## ADDENDUM ONE

### Request for Proposal 19057

### AIDEA/AEA Boardroom Audio/Video Buildout

May 16, 2019

Addendum One  
Attachment Two  
Picture Three  
Board Members Area/Side

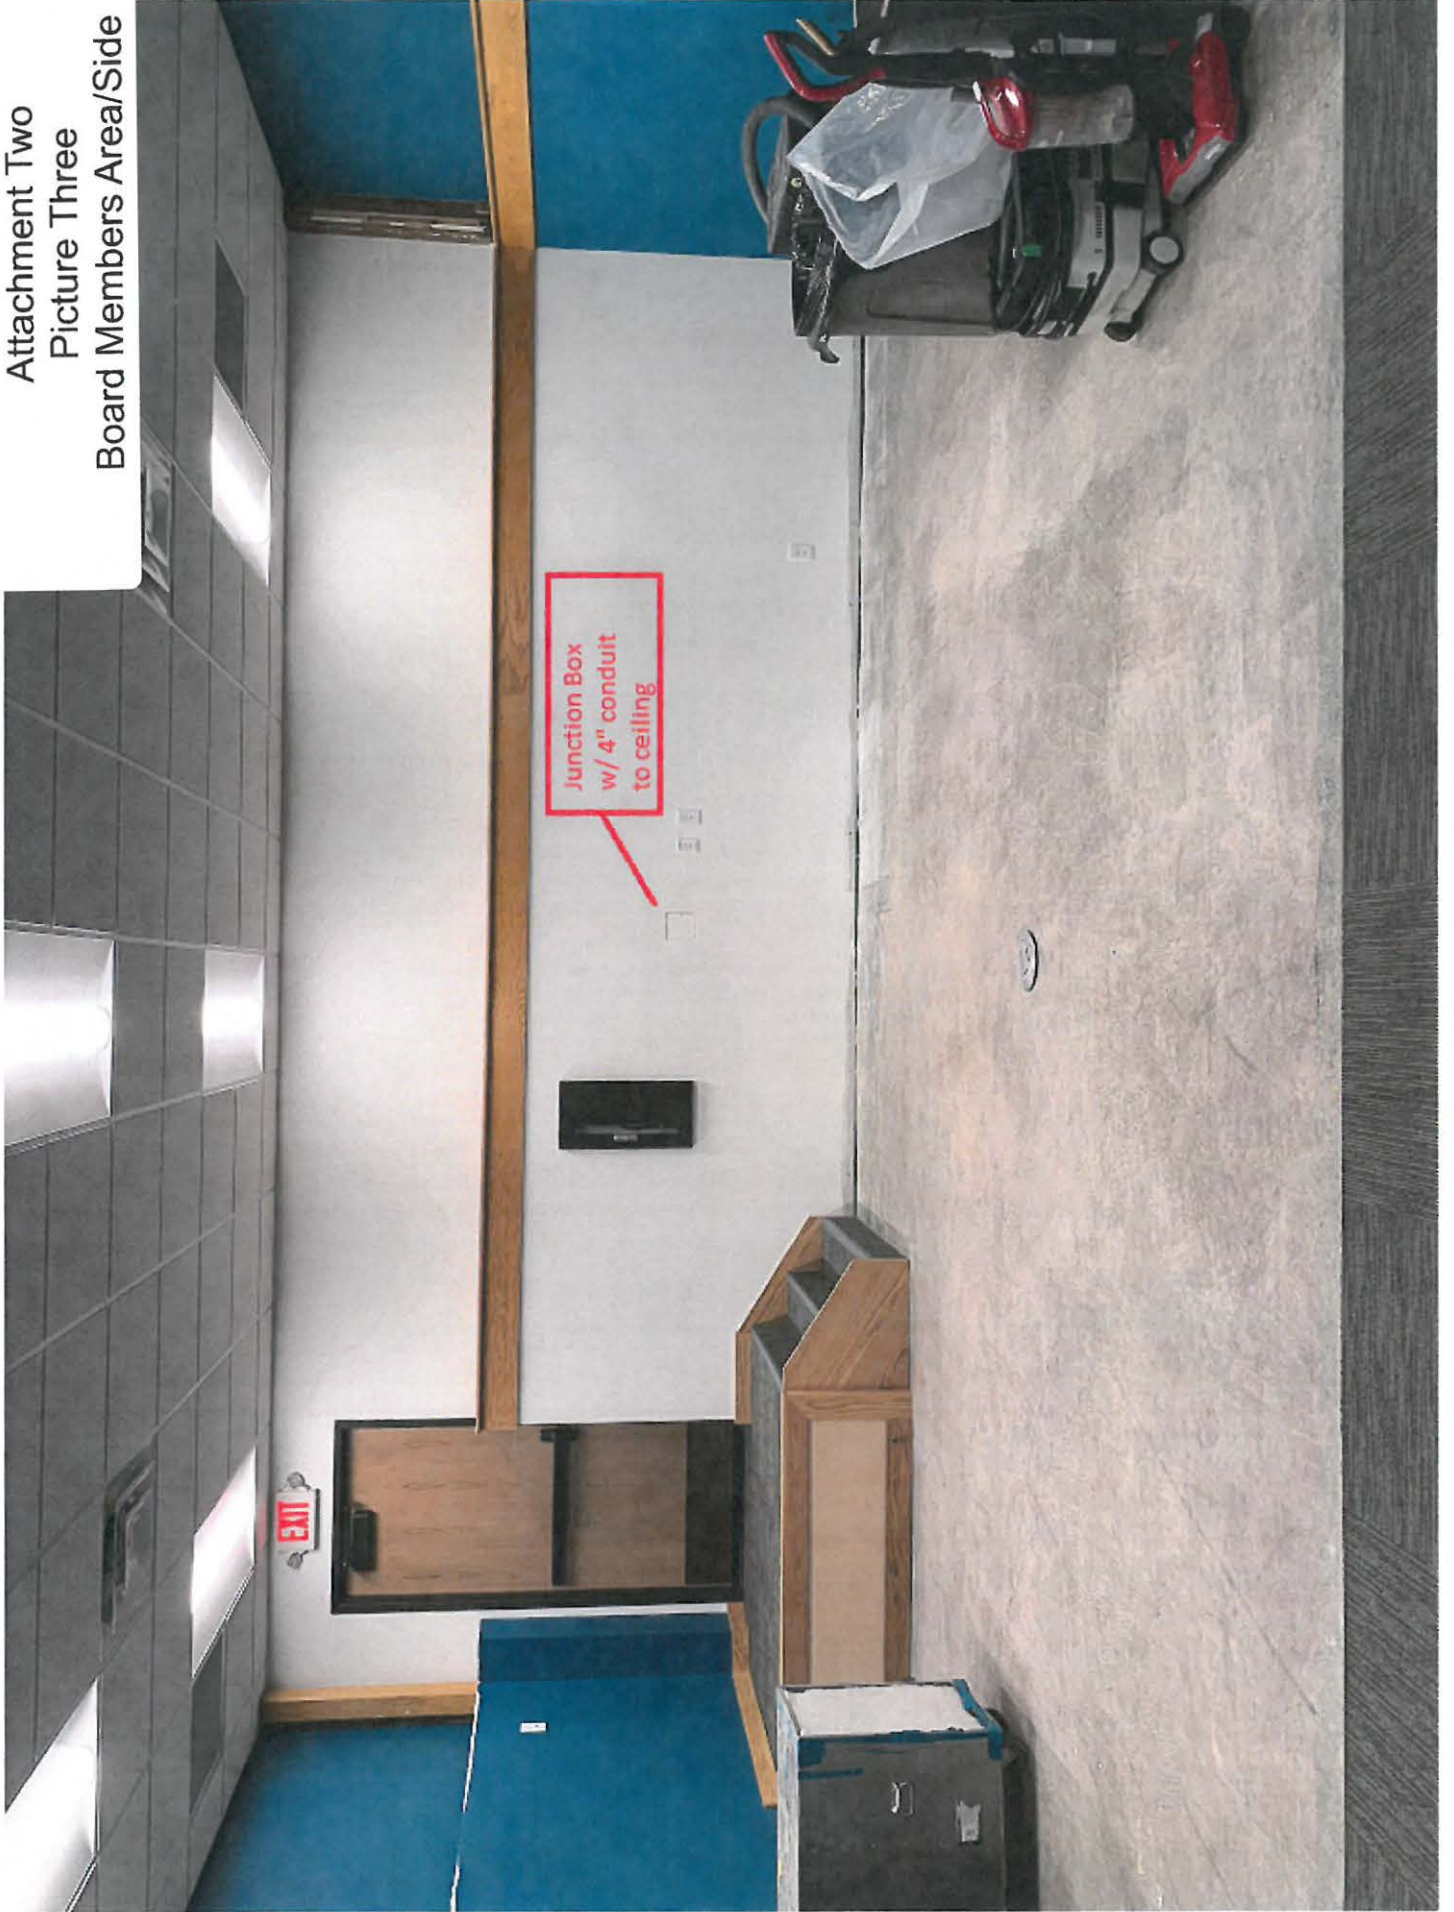
4. **Q:** Are there any physical features being added, that are not currently visible?

**A:** A raised platform is being added (see non-carpeted area in Picture Three). Electrical Conduit will run under this platform as needed.

# Addendum One Attachment Four

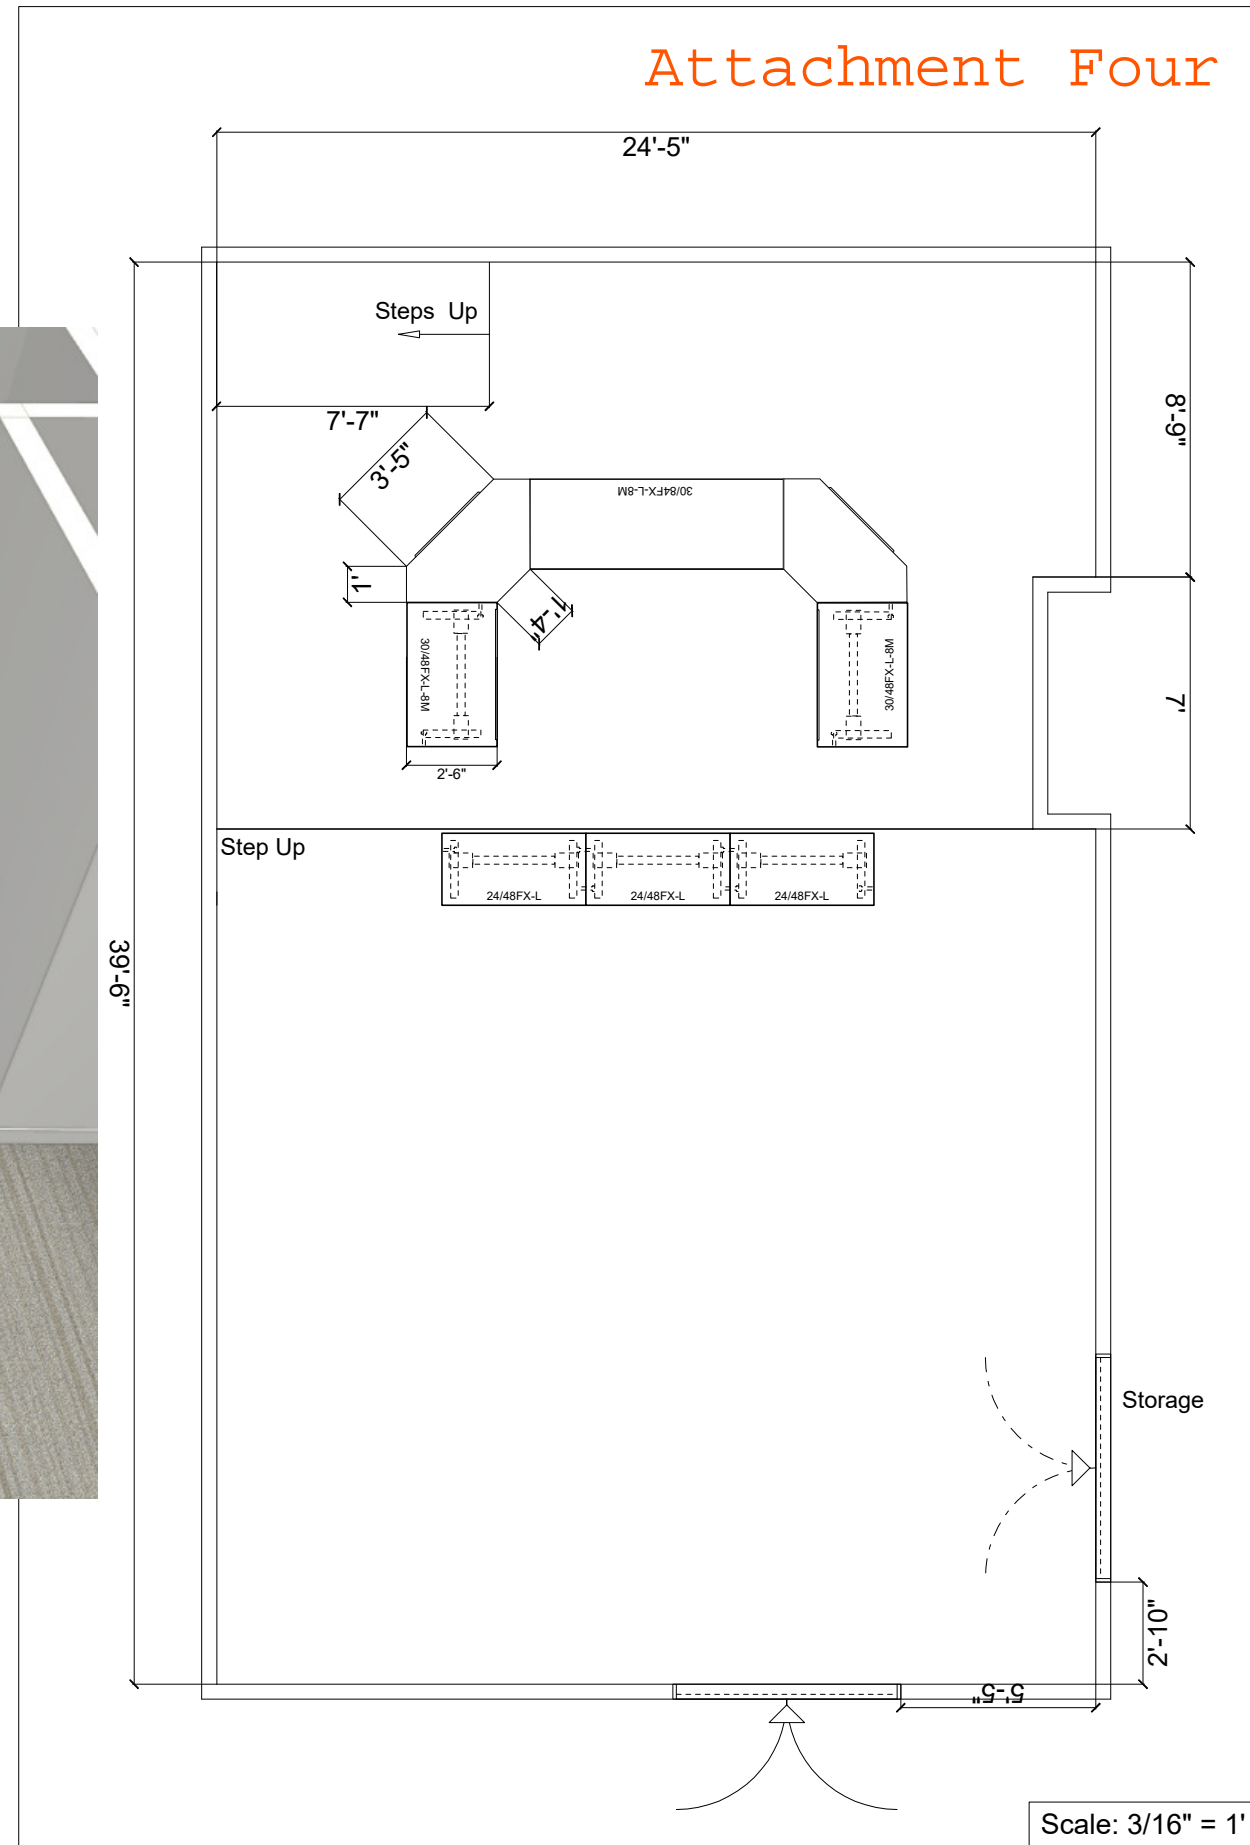
7. **Q:** Can you please provide the dimensions of the owner-furnished tables?
- A:** Please see **Attachment Four** (2 pages). Tables are equipped with Reef Power Unit. Attachment provides dimensions and specs.

Reef Multi Function Rectangular units will be field installed to insure proper placement.

- 1 Reef per Trapezoid
- 1 Reef per 24x28 Rectangle
- 1 Reef per 30x48 Rectangle
- 3 Reefs per 84"x 30" Rectangle
